UNITED STATES PATENT AND TRADEMARK OFFICE

APPLICATION NO.	FILING DATE	FIRST NAMED INVENTOR	ATTORNEY DOCKET NO.	CONFIRMATION NO.
09/754,537	01/04/2001	Bernard G. Harter	3174-000004	2550

Office Action Summary	Application No. 09/754,537	Applicant(s) HARTER ET AL.	
	Examiner Guillermo Perez	Art Unit 2834

DETAILED ACTION

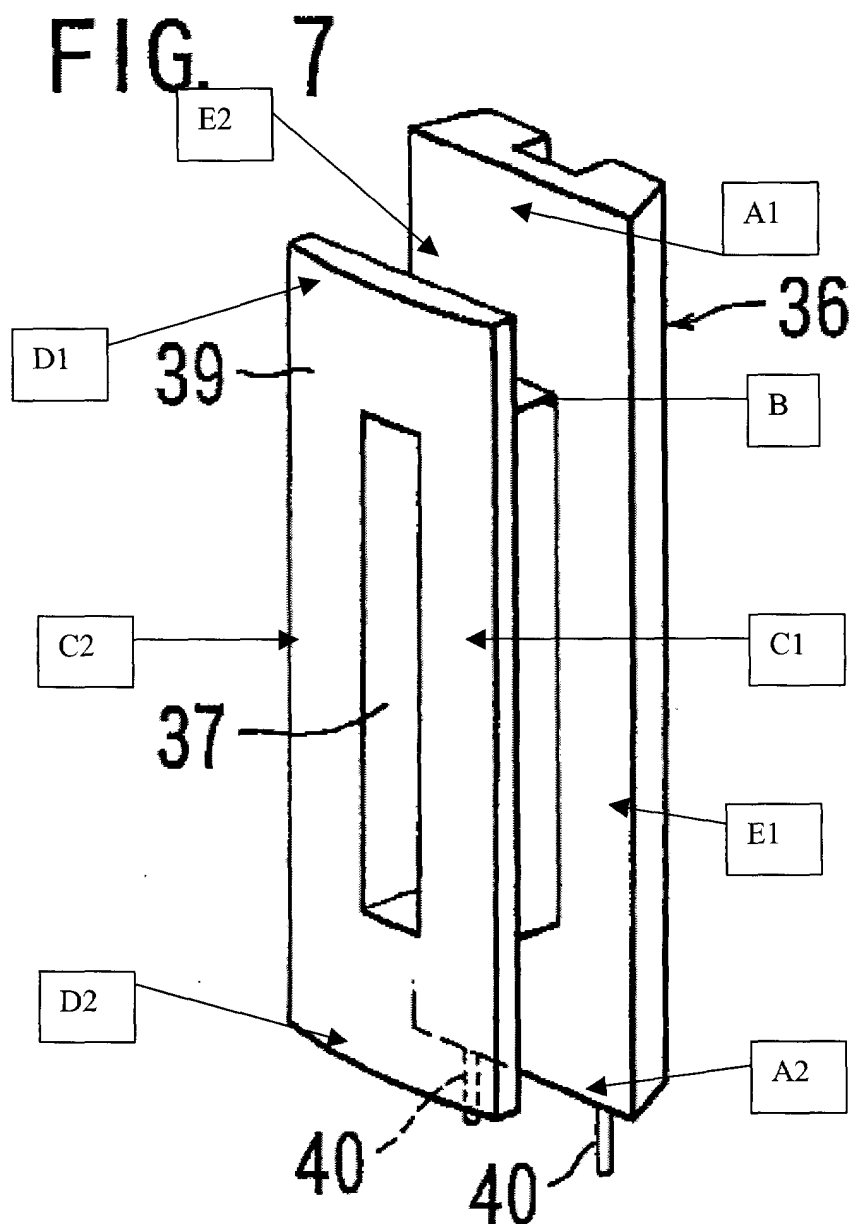
1. Claims 1-3, 5, 11-12, and 29 are rejected under 35 U.S.C. 102(e) as being anticipated by Suzuki et al. (U. S. Pat. 6,166,468).

Referring to claim 1, Suzuki et al. disclose in an electric machine with a circumferentially segmented stator:

- a winding end cap assembly (36) for a stator segment assembly including a stator core (34) that includes a plurality of stator plates that are stacked in an axial direction (column 4, lines 8-10) and that define a stator pole, comprising:
 - i. first and second end caps (A1,A2,D1,D2) that are connected to the stator plates of the stator core (34) that are located at opposite axial end surfaces of the stator core (34); and
 - ii. a first inner winding retainer section (E1) that extends axially to connect an inner end of the first end cap (A1,D1) to an inner end of the second end cap (A2,D2).

Referring to claim 2, Suzuki et al. disclose a second inner winding retainer section (E2) that extends axially to connect the inner end of the first end cap (A1,D1) to the inner end of the second end cap (A2,D2).

Referring to claim 3, Suzuki et al. disclose that the first and second end caps (A1,A2,D1,D2) include an outer section (D1,D2), an inner section (A1,A2) and a hub section (B) that connects the outer section (D1,D2) to the inner section (A1,A2).

Referring to claim 5, Suzuki et al. disclose winding wire (38) that is wound around the stator core (34) and the end cap assembly (36), wherein the winding end cap assembly (36) is not located between the winding wire and radial side surfaces of the stator core (at the D1,D2,A1,A2 locations as seen above and in figure 8).

Referring to claim 11, Suzuki et al. disclose that the first and second end caps (A1,A2,D1,D2) and the first and second inner winding retainer sections (E1,E2) define a continuous annular channel that receives winding wire (38).

Referring to claim 12, Suzuki et al. disclose first and second outer retainer sections (C1,C2) that connect the first and second end caps (A1,A2,D1,D2) adjacent to the outer sections of the first and second end caps (A1,A2,D1,D2).

the end cap assembly (36) is not located between the winding wire (38) and radial side surfaces of the stator segment core (34 at the D1,D2,A1,A2 locations as seen above and in figure 8).

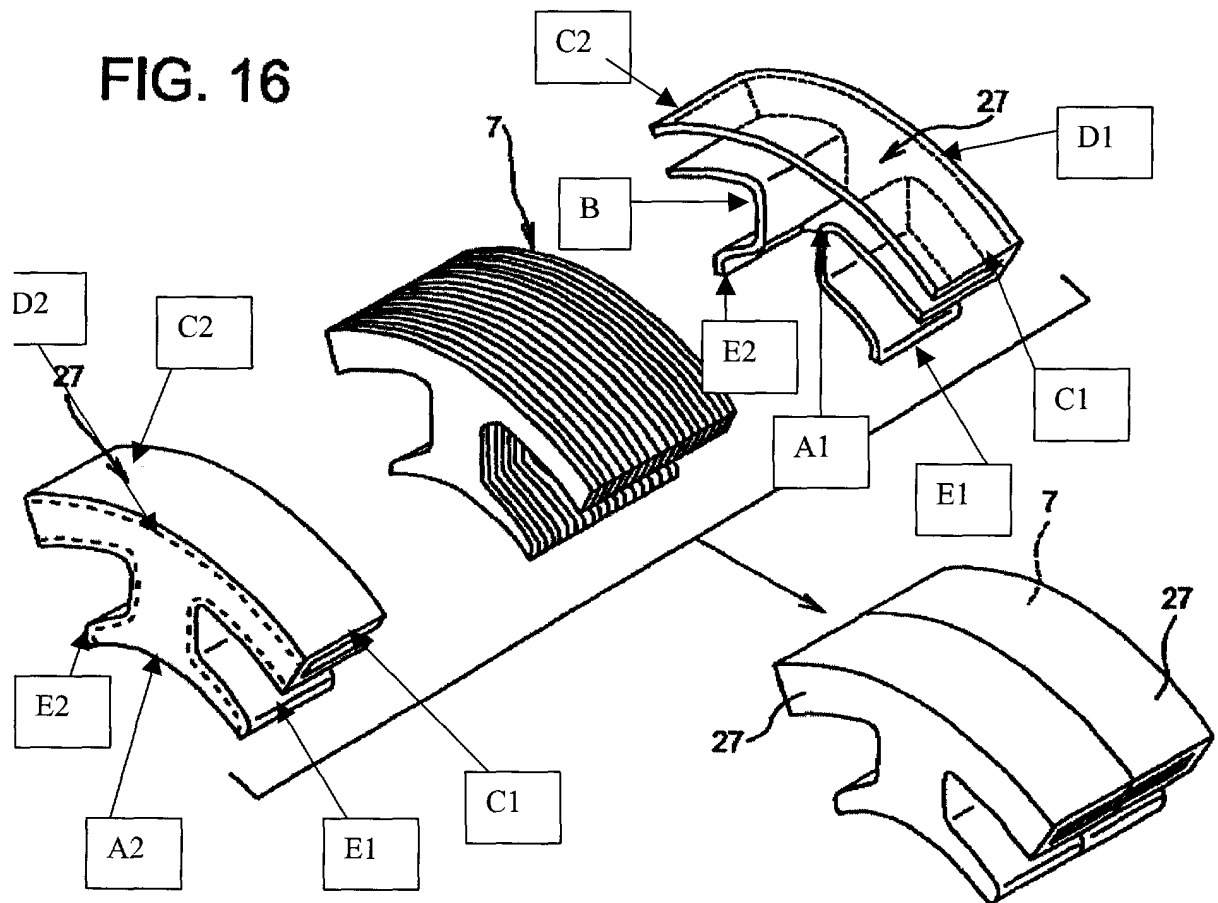
Kazama et al. discloses a stator segment assembly (figure 16) for a stator of an electric machine comprising:

an end cap assembly (27) that defines:

- a continuous annular channel and that includes:
 - i. first and second end caps (A1,A2,D1,D2) that are positioned adjacent to the stator plates that are located at opposite axial end surfaces of the stator segment core (34) and
 - ii. first and second inner winding retainer sections (E1,E2) that extend axially to connect inner ends (A1,A2) of the first and second end caps (A1,A2,D1,D2) together, wherein

the first and second inner winding retainer sections (E1,E2) engage inner ends of the tooth section; and

winding wire that is wound around the stator segment core (7) and the first and second end caps (A1,A2,D1,D2); wherein

the end cap assembly (27) is not located between the winding wire and radial side surfaces of the stator segment core (7).

Kazama et al. discloses that the first and second end caps (A1,A2,D1,D2) include an outer section (D1,D2), an inner section (A1,A2) and a hub section (B) that connects the outer section (D1,D2) to the inner section (A1,A2). Kazama et al. discloses

first and second outer retainer sections (C1,C2) that connect the first and second end caps (A1,A2,D1,D2) adjacent to the outer sections of the first and second end caps (A1,A2,D1,D2). Kazama et al. discloses insulation (B) that is located between the winding wire and the stator segment core (7).
